# ADMINISTRATIVE AMENDMENT

WYNDHAM RENOVATIONS

RHINO INVESTMENTS  
 NM HOTEL LLC  
 2500 CARLISLE BLVD NE  
 ALBUQUERQUE, NM 87110

### ADMINISTRATIVE AMENDMENT

A1 SITE PLAN

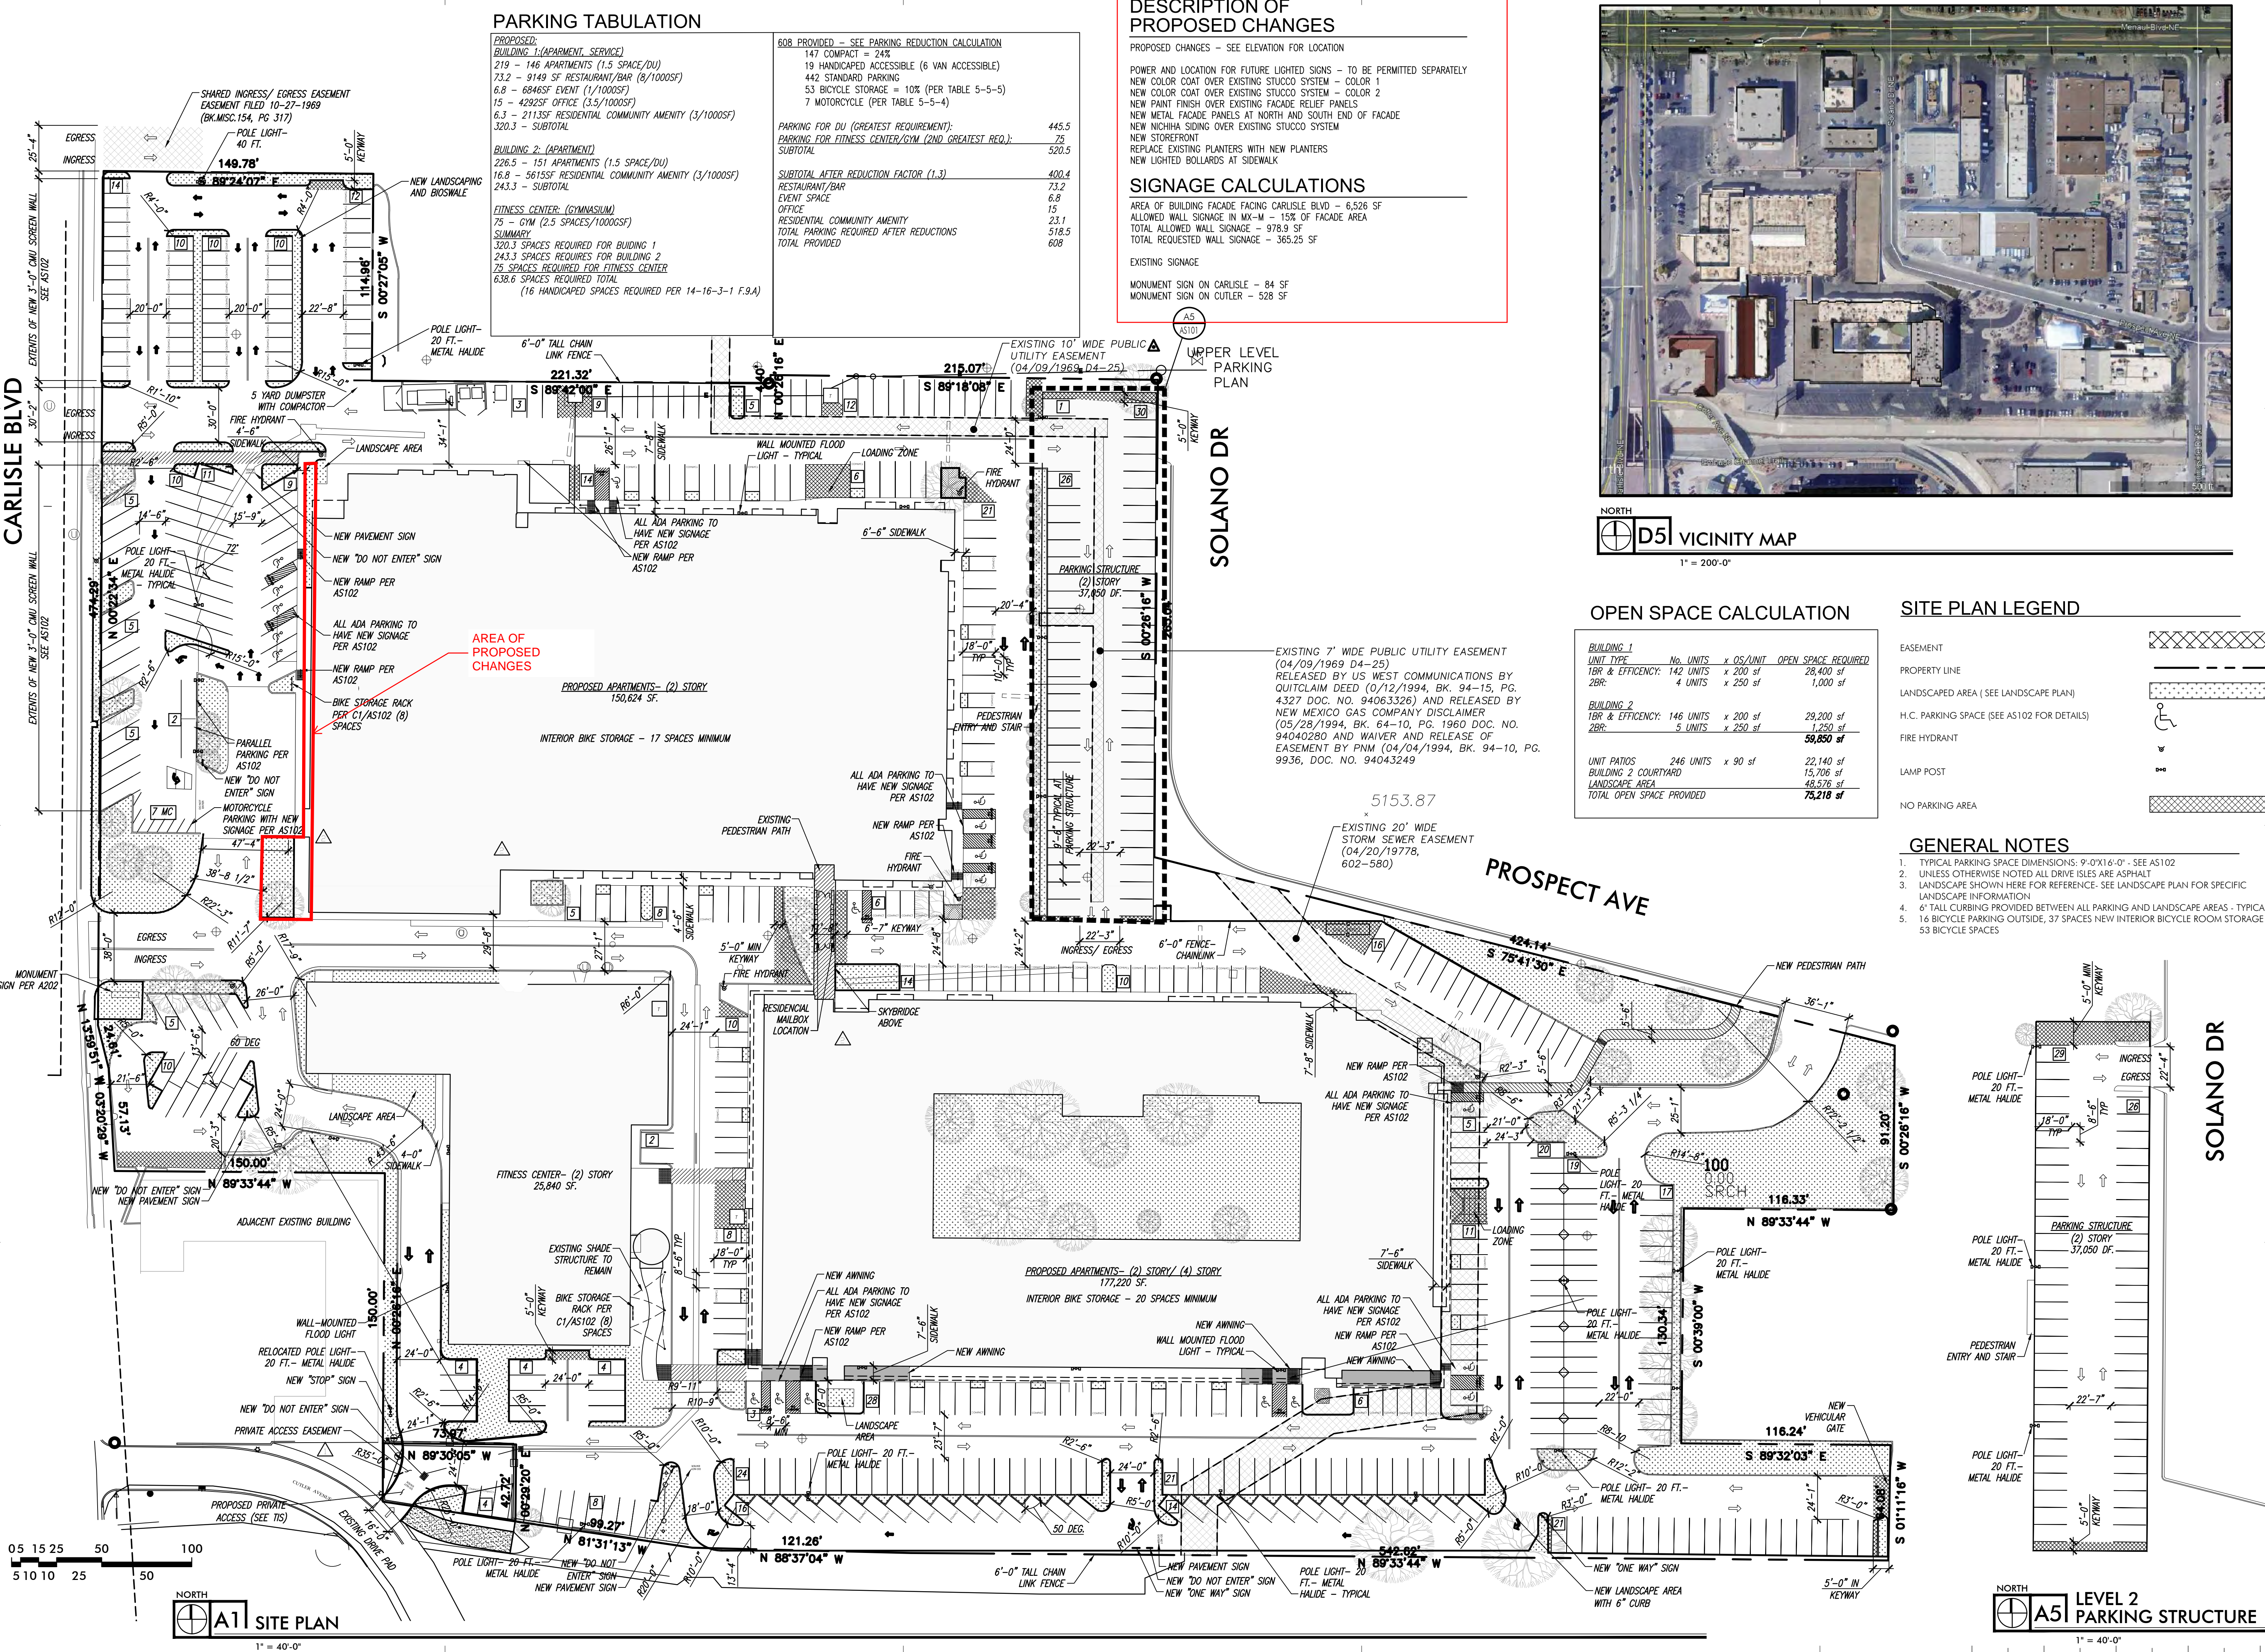
EXTENTS OF NEW 3'-0" CMU SCREEN WALL SEE AS102

### DESCRIPTION OF PROPOSED CHANGES

PROPOSED CHANGES - SEE ELEVATION FOR LOCATION

POWER AND LOCATION FOR FUTURE LIGHTED SIGNS - TO BE PERMITTED SEPARATELY

NEW COLOR COAT OVER EXISTING STUCCO SYSTEM - COLOR 1

NEW COLOR COAT OVER EXISTING STUCCO SYSTEM - COLOR 2

NEW PAINT FINISH OVER EXISTING FACADE RELIEF PANELS

NEW METAL FACADE PANELS AT NORTH AND SOUTH END OF FACADE

NEW NICHHA SIDING OVER EXISTING STUCCO SYSTEM

NEW STOREFRONT

REPLACE EXISTING PLANTERS WITH NEW PLANTERS

NEW LIGHTED BOLLARDS AT SIDEWALK

**A1** PROPOSED WEST FACADE

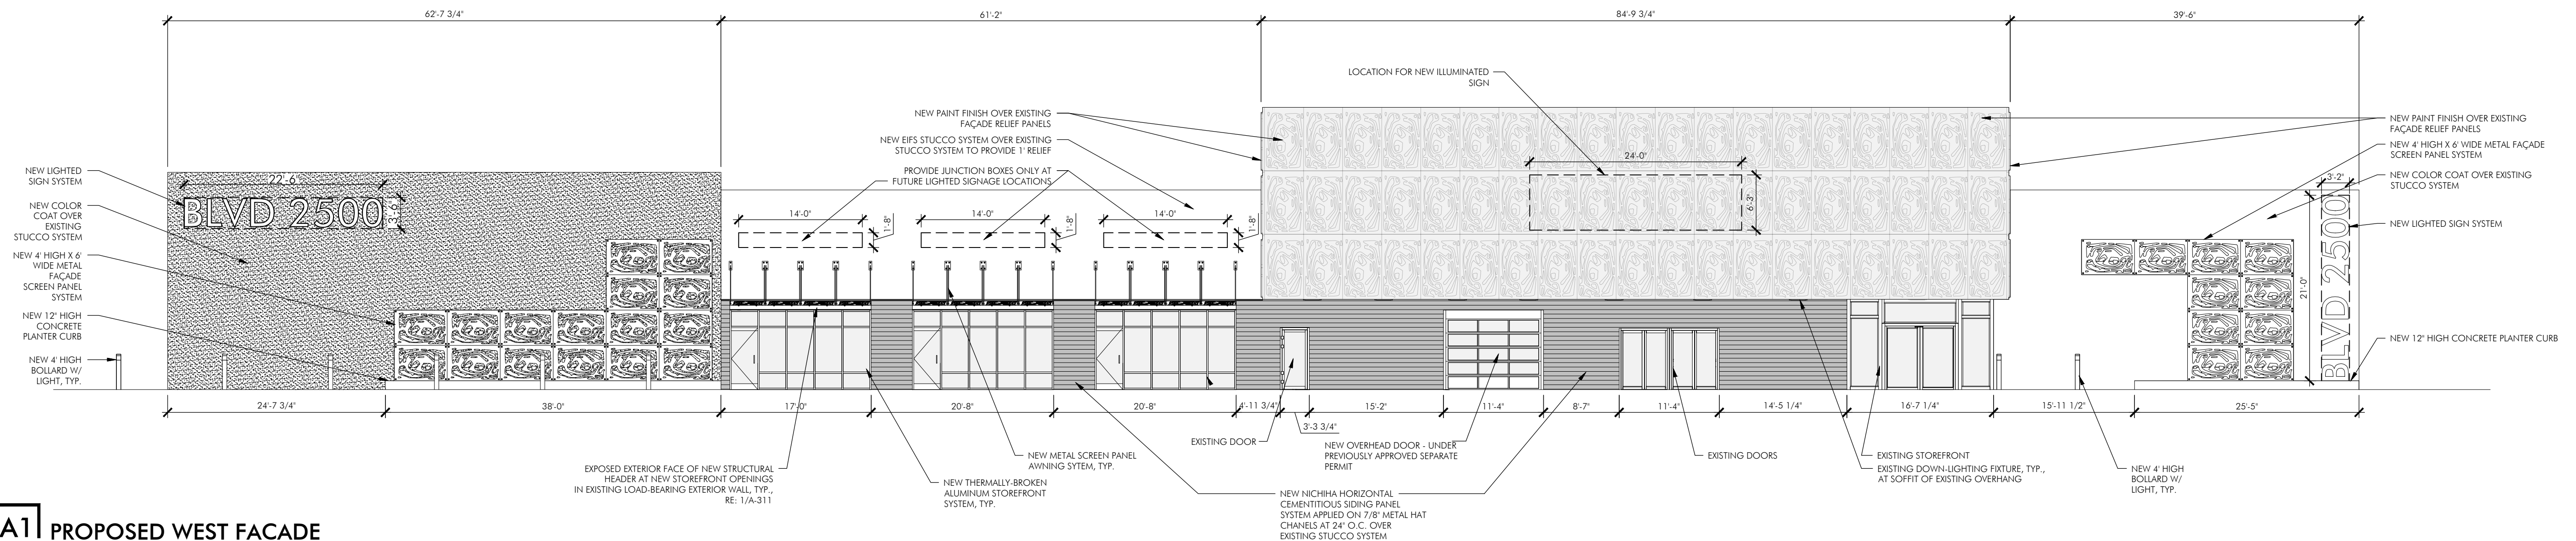
**DESCRIPTION OF PROPOSED CHANGES**

POWER AND LOCATION FOR FUTURE LIGHTED SIGNS - TO BE PERMITTED SEPARATELY

- NEW COLOR COAT OVER EXISTING STUCCO SYSTEM - COLOR 1 
- NEW COLOR COAT OVER EXISTING STUCCO SYSTEM - COLOR 2 
- NEW PAINT FINISH OVER EXISTING FACADE RELIEF PANELS 
- NEW METAL FACADE PANELS AT NORTH AND SOUTH END OF FACADE 
- NEW NICHHA SIDING OVER EXISTING STUCCO SYSTEM

NEW STOREFRONT  
 REPLACE EXISTING PLANTERS WITH NEW PLANTERS  
 NEW LIGHTED BOLLARDS AT SIDEWALK
